R867 Rev 0

February 2017

City of Greater Geraldton

**Whitehill Road Boat Launching Facility
Concept Investigations**

Figure 5.3 Option 3 Layout Plan

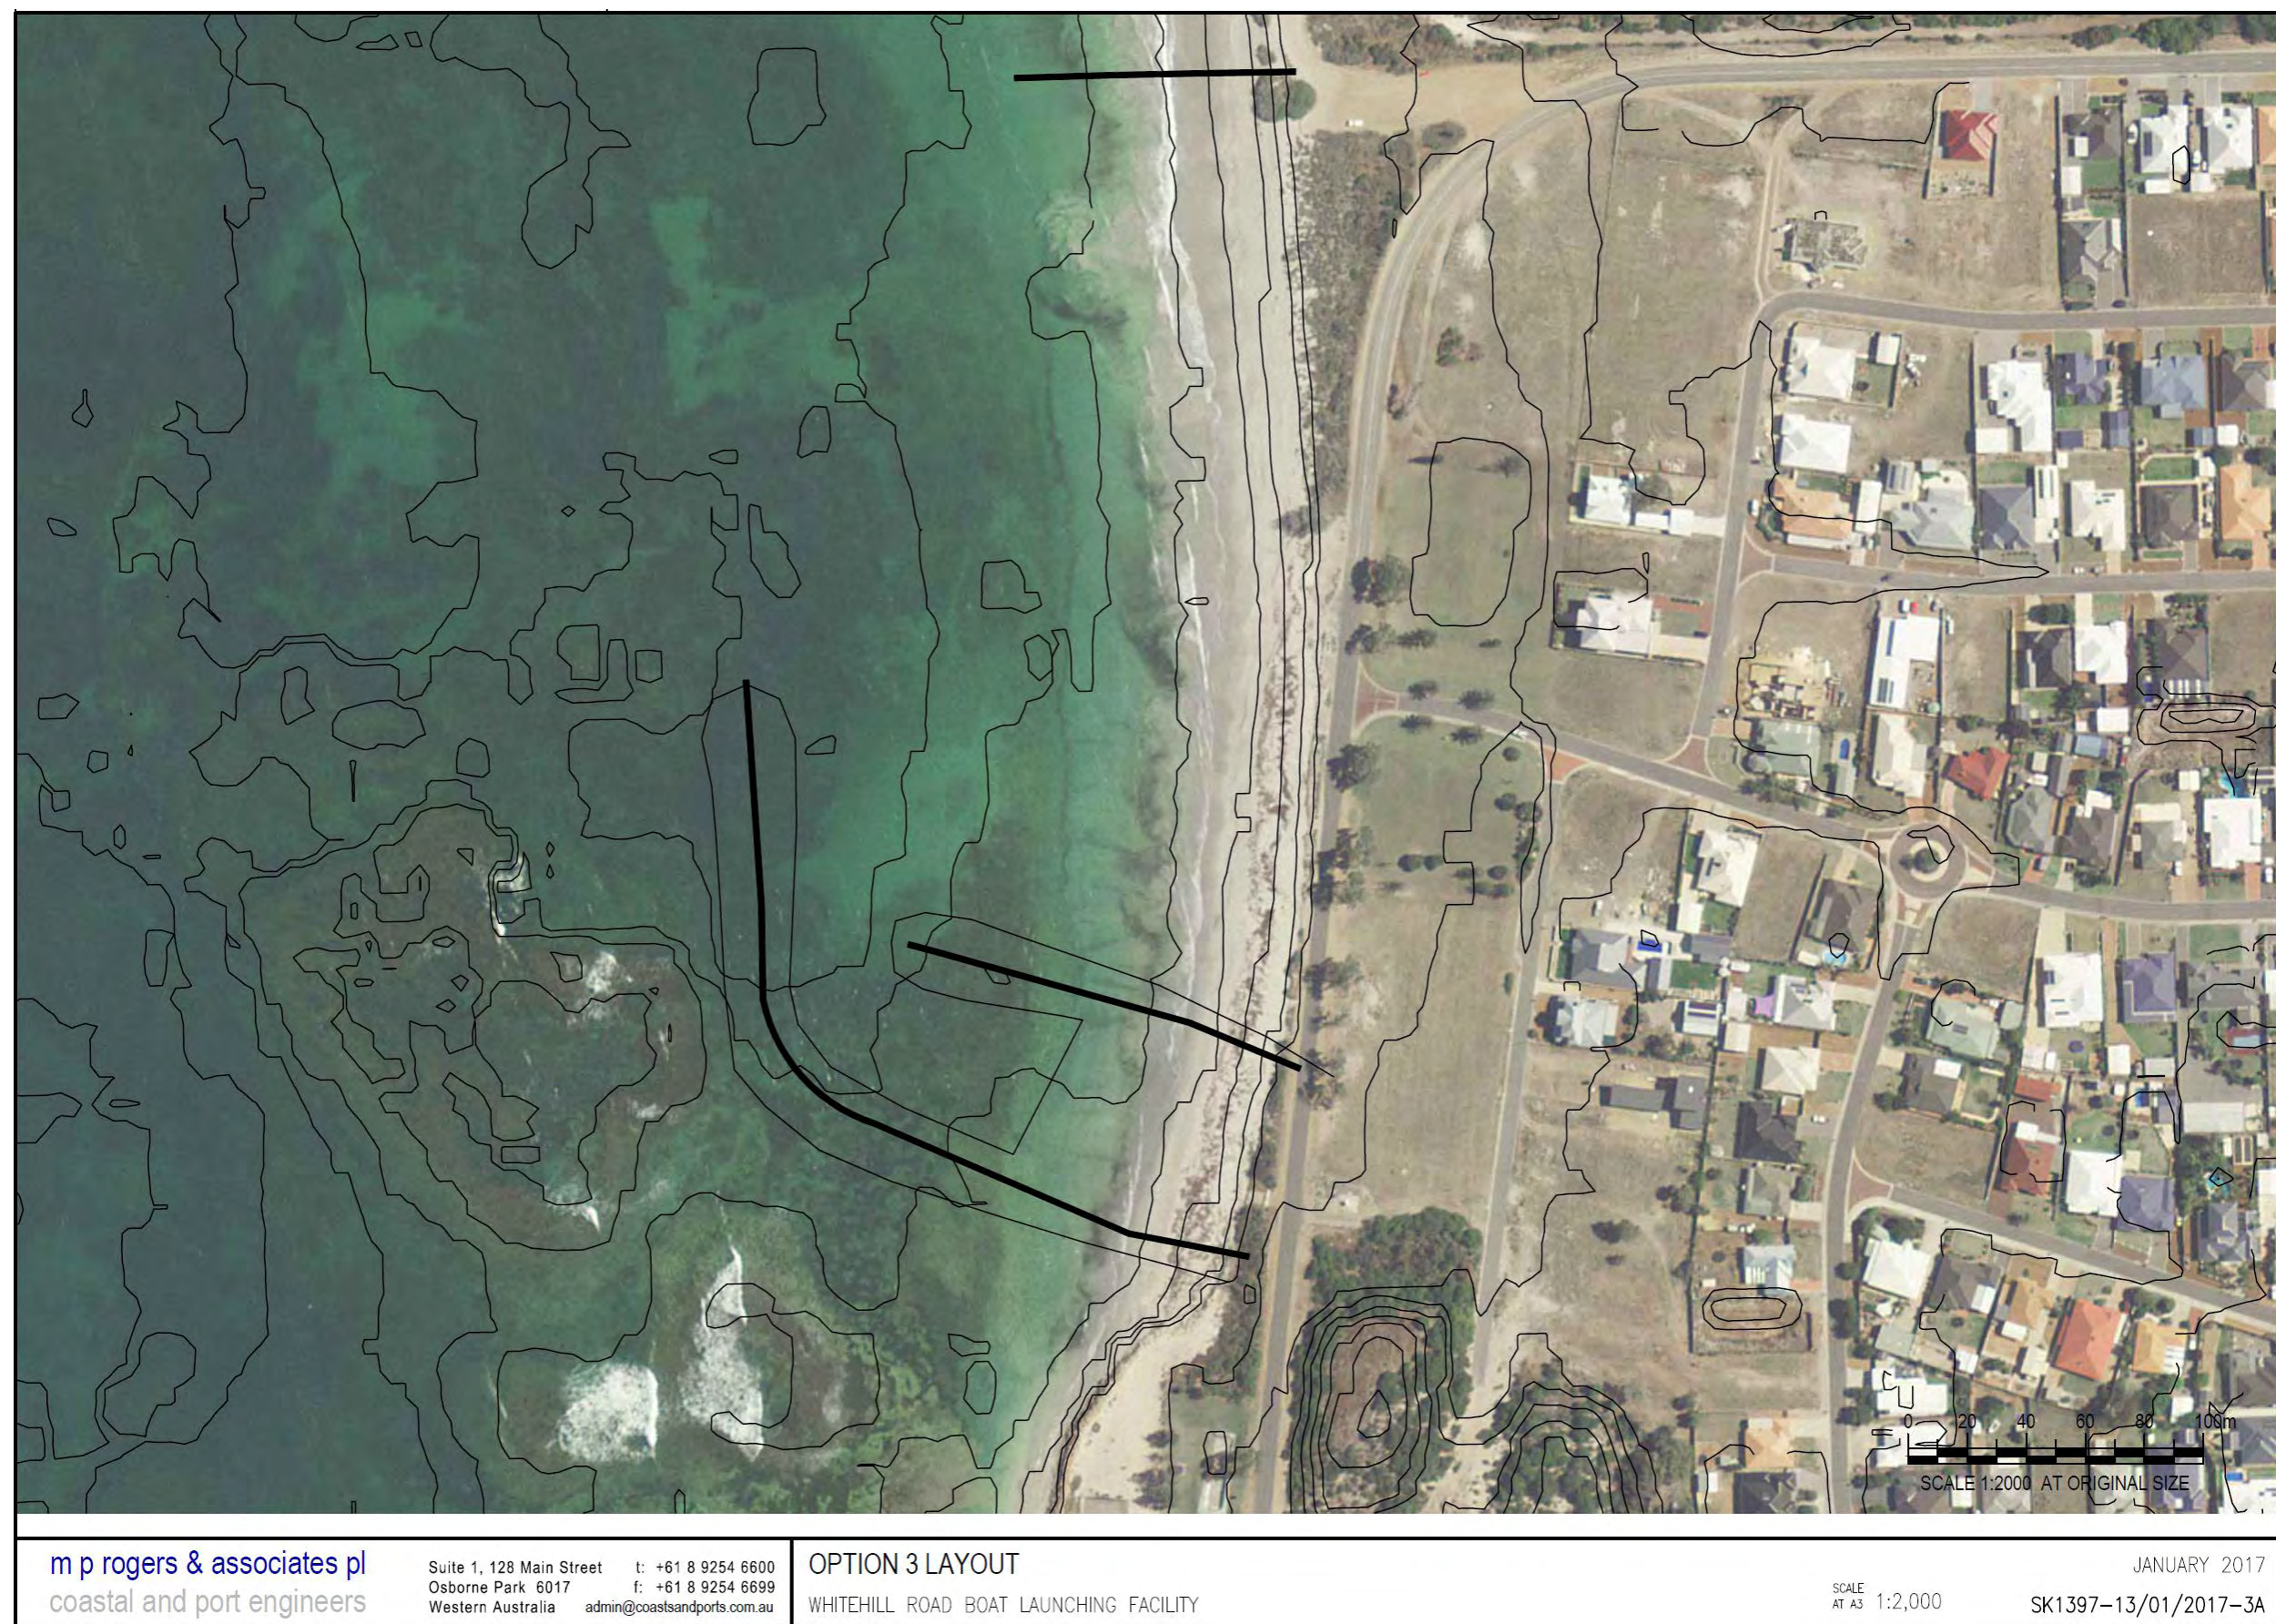
Option 3 provides a fully enclosed water area, however the relatively small facility would provide direct protection to only a small portion of the foreshore (refer Figure 5.3). An analysis of the potential issues and benefits associated with this option are presented in Table 5.5.

Positive Aspects	Negative Aspects
<ul style="list-style-type: none">■ Creates a fully enclosed water area that would provide a suitable wave climate for launching and retrieving vessels.■ Provides direct protection to some assets along the southern portion of the site.	<ul style="list-style-type: none">■ The small footprint of the facility would only provide direct protection to a small portion of the foreshore. Other erosion mitigation measures would likely be required immediately to the north.
